Agenda
Village of Arlington Heights
Design Commission
Community Room, 3rd Floor
Arlington Heights Village Hall, 33 S. Arlington Heights Rd.
February 28, 2023
6:30 PM

**Design Commission
2/28/2023**

MINUTES OF THE VILLAGE OF ARLINGTON HEIGHTS DESIGN COMMISSION

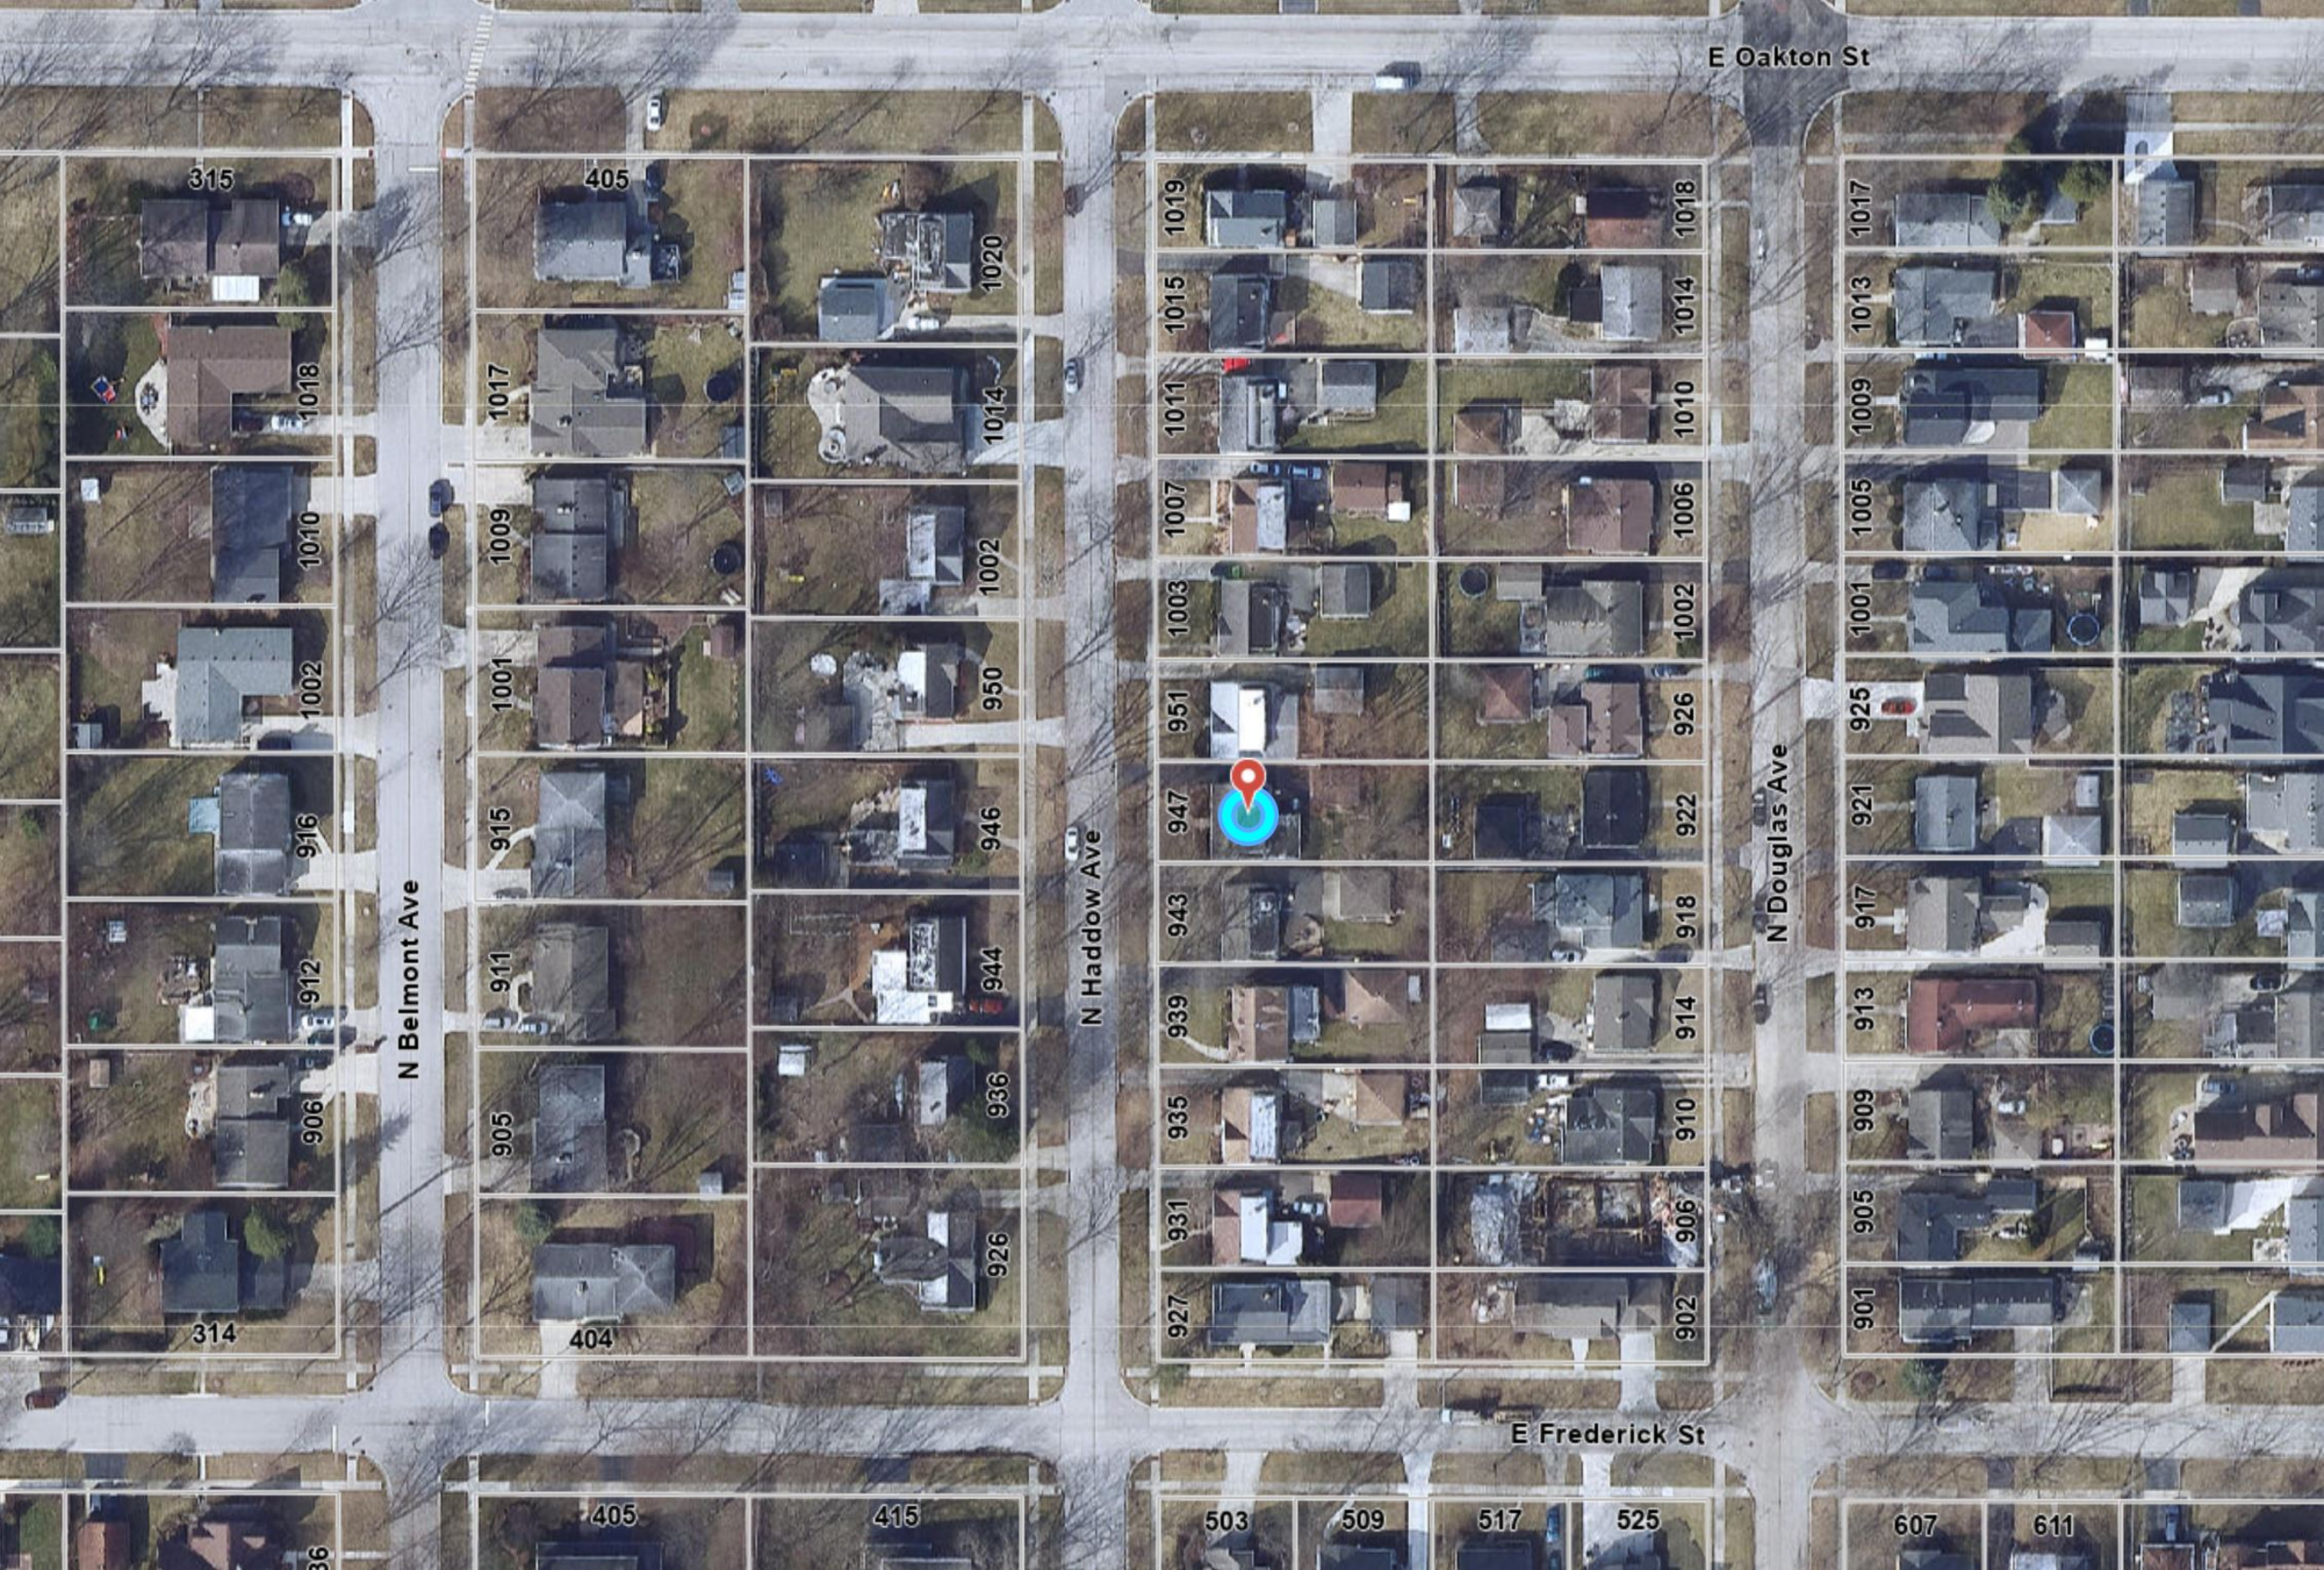
The subject property is located on a street with mostly original homes that are single-story and one-and-a-half-story houses with detached garages. There is one teardown previously completed on this block with an attached front load garage, but the proposed two-story house with attached garage does not fit with the character of the block. A better plan in this location would include a detached garage, or an attached garage that is recessed behind the front wall of the house.

1. Evaluate the proposed attached garage against the surrounding context of detached garages. Consider a revised design with a detached garage or an attached garage that is recessed behind the front wall of the house.
2. A recommendation to lower the roof pitch of the right gable to match the roof pitch of the left gable, and to lower the main roof ridge to

- reduce the overall bulk and mass to better fit with the scale of the surrounding homes.
3. A softer color scheme is recommended to better fit with the character of the block.

4. Provide 8 feet minimum clearance between the new driveway and the existing parkway tree.
 5. This review deals with architectural design only and should not be construed to be an approval of, or to have any other impact on, any other zoning and/or land use issues or decisions that stem from zoning, building, signage or any other reviews. In addition to the normal technical review, permit drawings will be reviewed for consistency with the Design Commission and any other Commission or Board approval conditions. It is the architect/homeowner/builder's responsibility to comply with the Design Commission approval and ensure that building permit plans comply with all zoning code, building permit and signage requirements.
